## Engineering Change Notification

### **NHD-COG14-36**

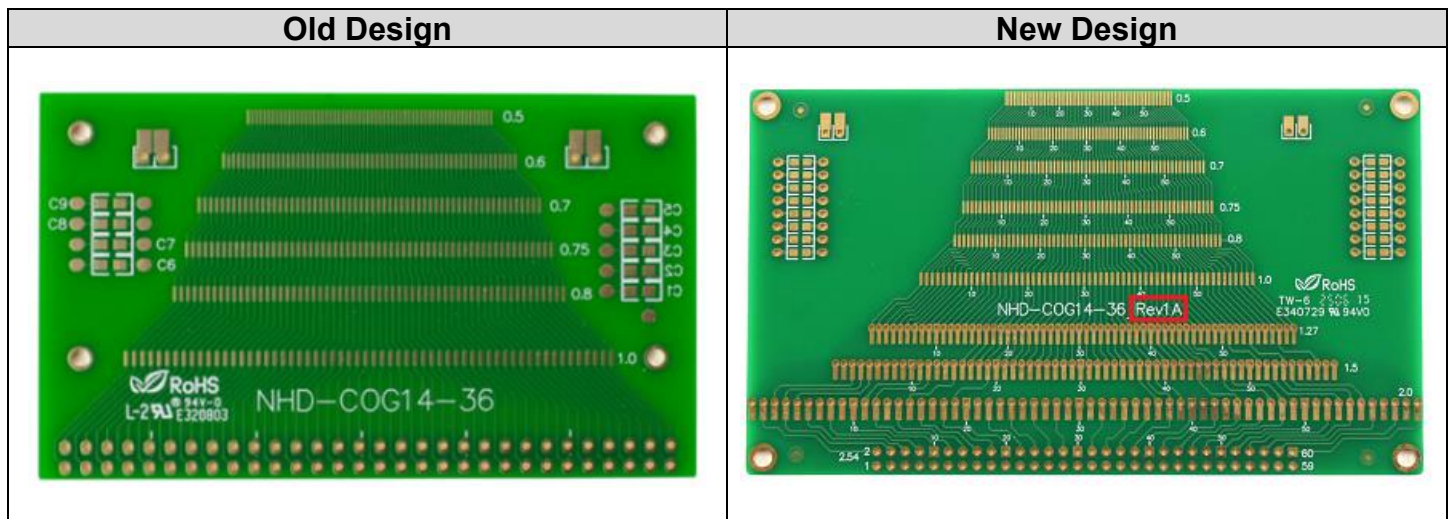
This breakout PCB has been redesigned to add support for additional connection types. The board now supports 1.27mm, 1.5mm, and 2.0mm pitch SMT and thru-hole connections also. This design improvement has led to an increased overall size of the PCB.

The new board will be labeled with a different revision control number after the part number. See example below.
